**Re: Application No.: A/TM/589 - F.I. Submission for Sec. 16 Application to permit "Shop & Service (Real Estate Agency) use at Unit G2B, Ground Floor, Parklane Centre, 25 Kin Wing Street, Tuen Mun, N.T. (TMTL 370)**

Further to FSD & TD comments received on 22 January 2024, we submit here with a RtoC table (1 page) and revised proposed layout plan (Dwg. No. A-03 Rev. A) (1 page) for your onward processing/ approval.

**S16 Application for Proposed Shop and Services (Real Estate Agency)**  
**Unit 2B, G/F, Parklane Centre, 25 Kin Wing Street, Tuen Mun, New Territories**  
**Response to Comments**

DWG NO.  
A-03

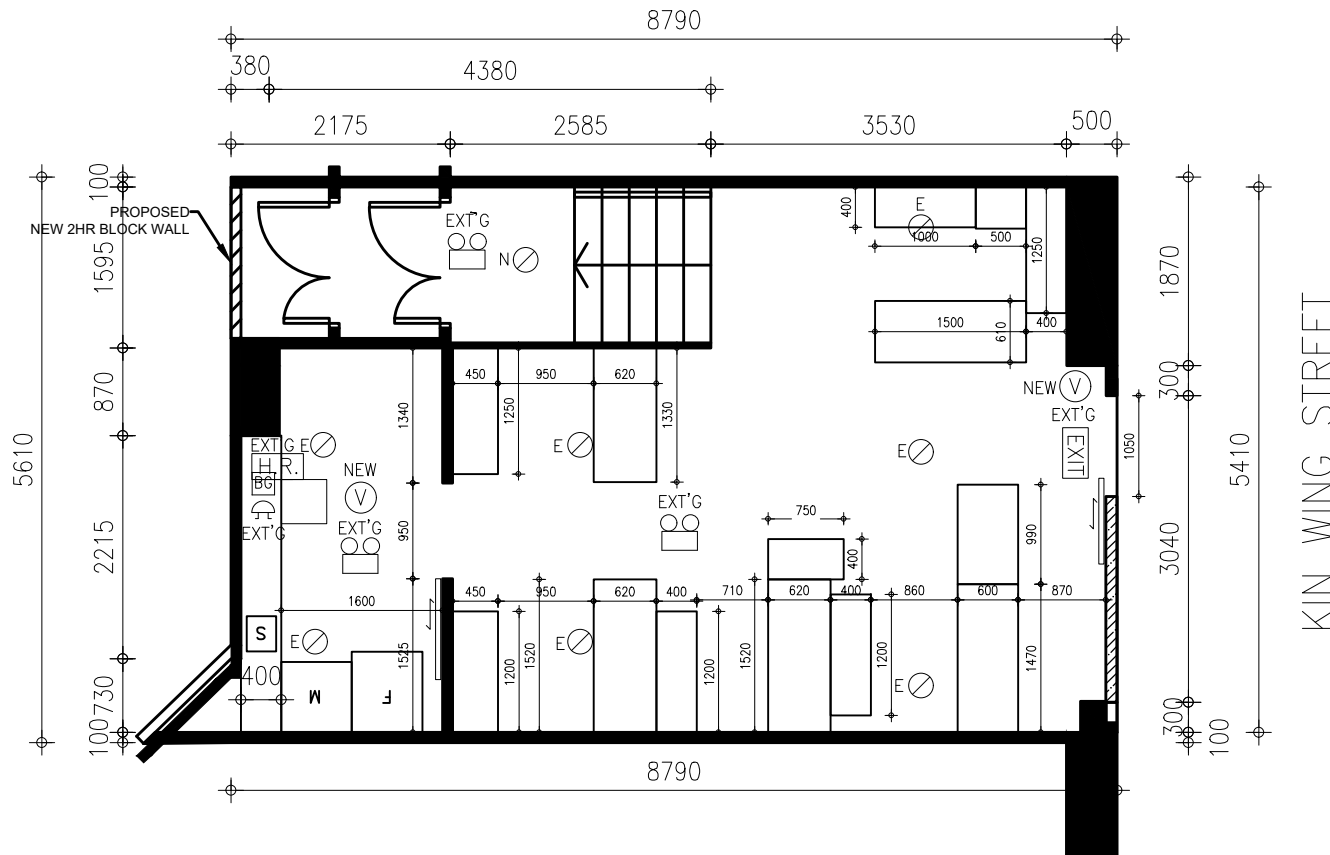
3. Please provide the Level of Service (LOS) assessment of the existing footpath for our further consideration.	With reference to the guidelines in "Highway Capacity Manual 2010 - Table 5-2" Description of Level of Service (LOS) for Footpaths, the LOS is category A, as there are less than 16 pedestrians/min/m. Visual inspection reveals that it is not a busy area.
Comments from <b>Fire Services Department</b> (Contact Person: Mr. CHENG Tsz-to, Tel: 3971 4651) received on 22 January 2024 via email	
Base on the submitted information, the application is not supported. The applicant should clarify whether the area under this application is completely separated from the industrial portion. All construction material/ partition wall with fire resistance rating should be indicated on plans for our further consideration.  Regarding matters related to fire resisting construction of the premises, please reminded to comply with the "Code of practice for Fire Safety in Buildings" which is administered by the Building Authority.	We propose a new 2 hour fire rated block wall beyond the protected lobby as shown on the revised layout plan Dwg. No. A-03(Rev A), so that the "application premises" can be separated and considered as an individual unit.
